Fig. 4(b)

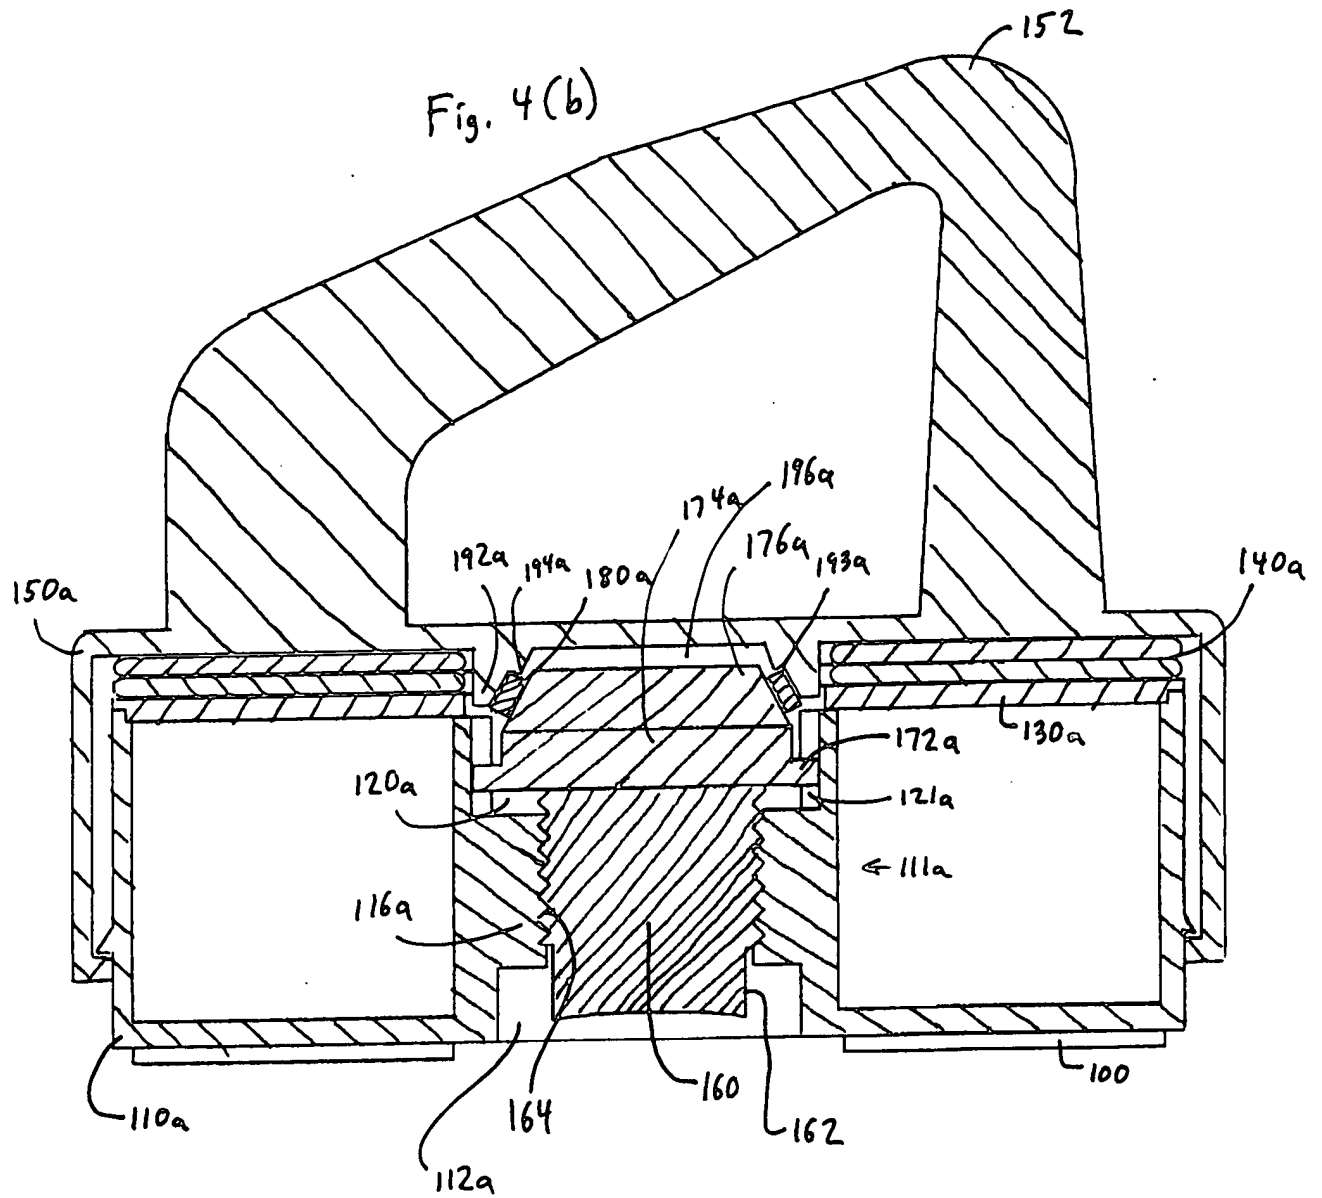
Applicant attaches hereto proposed drawing corrections to Figures 4(b), 5(b), 6(b), 7(a)-(c), and 8(h) shown in red ink. Reference numeral 111a representing the central passageway is proposed to be added to Figure 4(b). Reference numerals 110b representing the lower housing and 111b representing the central passageway are proposed to be added to Figure 5(b). In Figure 6(b), it is proposed to remove reference numeral 121c, add additional stippling to element 115, and add reference numeral 180c representing the friction material. It is proposed to add reference numeral 160d representing the adjustment device to Figures 7(a)-(c). Reference numeral 110e representing the lower housing is proposed to be added to Figure 8(h).
